Accredited Standards Committee  
X3, Information Processing Systems

Doc: X3T10.1/96a165r2  
Date: September 30, 1996  
Project: X3T10.1 / 1146D  
Ref Doc.: SSA-PH2 rev 3  
Reply to: John Scheible

To: X3T10.1 Membership  
From: John Scheible  
Subject: Changes to SSA-PH3 rev 3

Figure 1 - Port connection segment test load

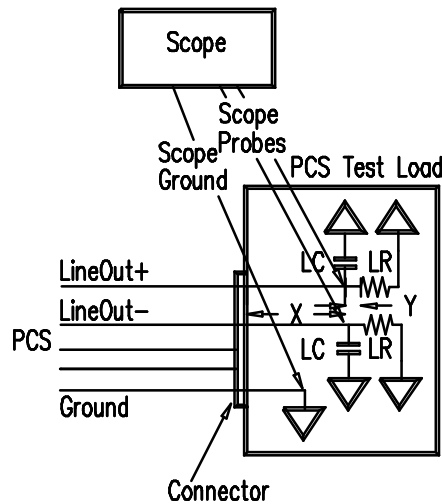
During the discussions on Port Connection Segment testing at Ithaca the Port Connection Segment Test Load was generated. There was some discussion between myself and Bill Ham as to where the scope should be connected. In the end Bills view prevailed and rev 3 shows the scope connected to the connector pins.

Since then I have done some measurements which show that the addition of even 0,4pF of scope probe added at the connector pins causes the impedance at the connector (as seen by a TDR at 375ps risetime) to fall from 137 ohms to 129 ohms. If however the same scope probes are connected at the point at which LC would appear then the impedance at the connector is unaffected. In addition, by connecting the scope probes across the capacitors, which represent the silicons input capacitance, then the signal displayed by the scope will be the signal that the silicon will see. In effect placing the scope across the capacitors removes the disruptive effect of the scope probes from the measurement.

Tests to determine the value of LC required to cause the dip in the TDR plot below 120 ohms for 375pS resulted in a value of around 2.5pF (0805 cap). As the scope probes which most seem to use have capacitances close to this value, placing this much capacitance at the connector would cause the test load with scope probes

attached to fail the requirements of 7.3 as there would be two dips below 120 ohms, one at the connector and one at LC.

Figure 16 should therefore be amended to show the scope probes connected across LC.

CHANGES: Change Figure 16 and the preceding paragraph as follows:

The driver test environment shown in 7.1.3 and the associated measurement procedure shall be used when setting the input signals applied at point M2. Once the input signals have been set, the port connection segment shall be connected in place of the driver test load and measuring equipment. The Port Connection Segment test load (see Figure 1) and the measurement procedure shown in 7.1.3.1 shall be used at point M3. The Port Connection Segment test load with scope probes attached shall conform to the characteristic impedance requirements in 7.3 at its connector. The value of each of the two capacitors LC shall be adjusted such that the total capacitance of LC and its associated probe causes the impedance around its time point, measured from its respective LineIn to ground, to fall below 60 ohms for 360 to 375ps. Typically the total capacitance of LC and scope probe will be in the order of 2.5pF. The values of LR, X and Y in Figure 1 shall be  $75 \Omega \pm 1\%$ ,  $5 \text{ cm} \pm 5 \text{ mm}$ , and  $5 \text{ mm} \pm 1 \text{ mm}$  respectively.

Note: Lineout+ and LineOut- in the figure should be LineIn+ and LineIn-.
